NOTICE TO ALL FIRMS

Re: Addendum Number 1
IFB # C1590 – Museum Lighting (GC)

WAVELINX LIGHTING CONTROL RISER

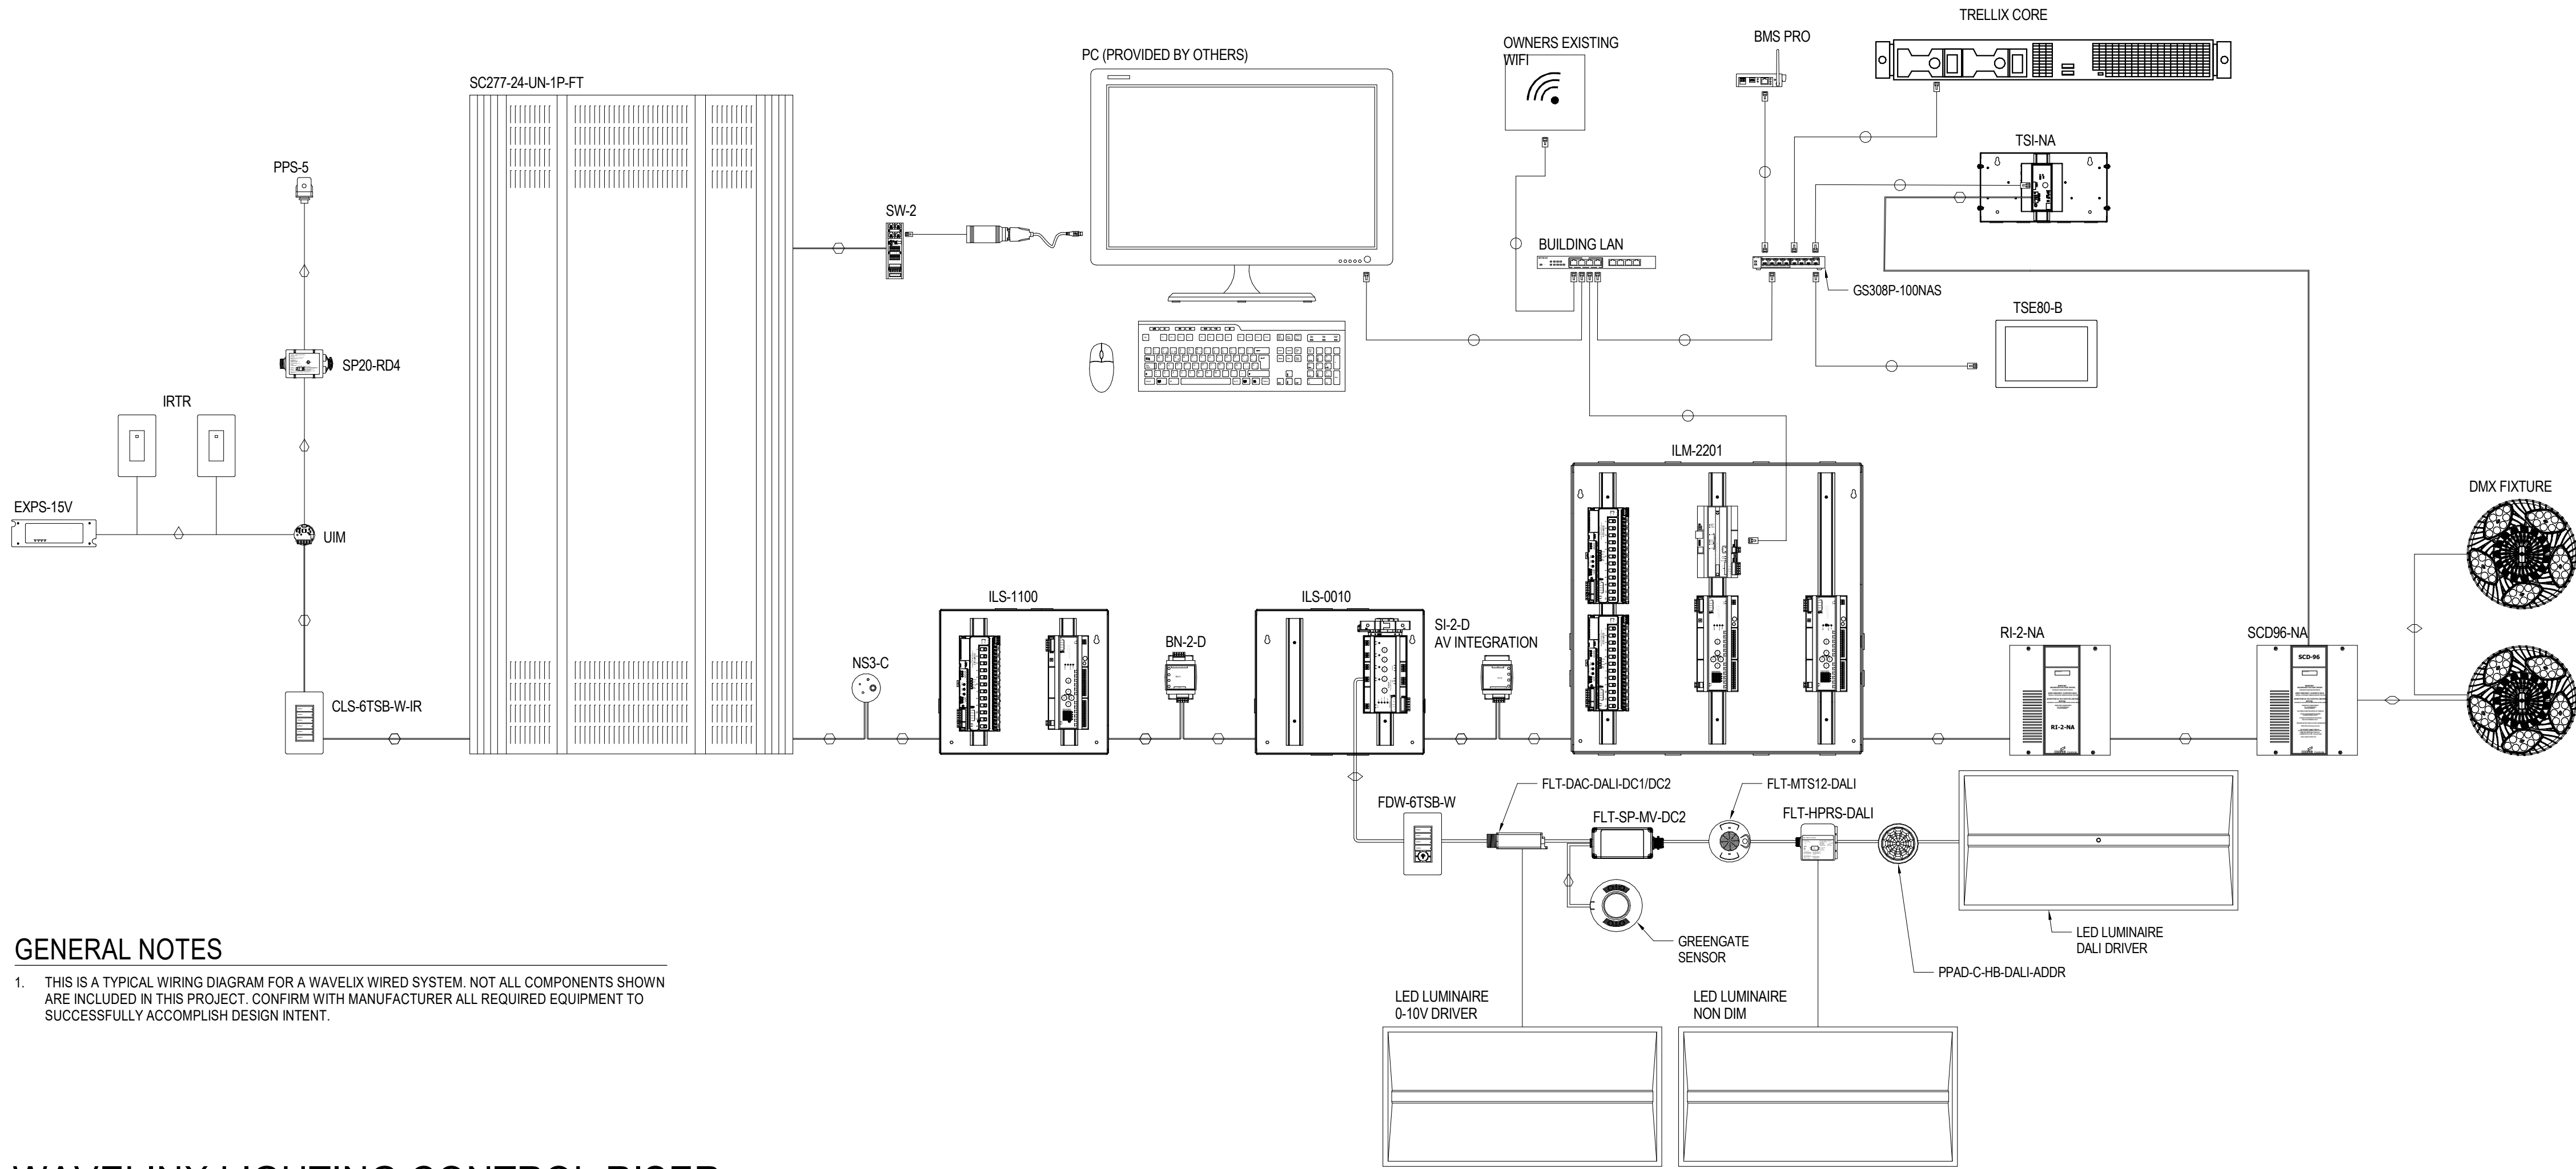
1. Model/Series for RT1, RT2, & RT3 on Luminaire Schedule (E7.1) previously had 6A circuitry & has been corrected with 2A circuitry. Clarification shall have no effect on pricing. (See attached updated drawings)
2. LP-ECC1 & LP-ECC on Lighting Plan (E1.0) & Power & Systems Plan (E2.0) previously were shown on the drawing without a keynote & have been clarified with Keynote # 8 advising that these panels are in the subcellar. (See attached updated drawings)
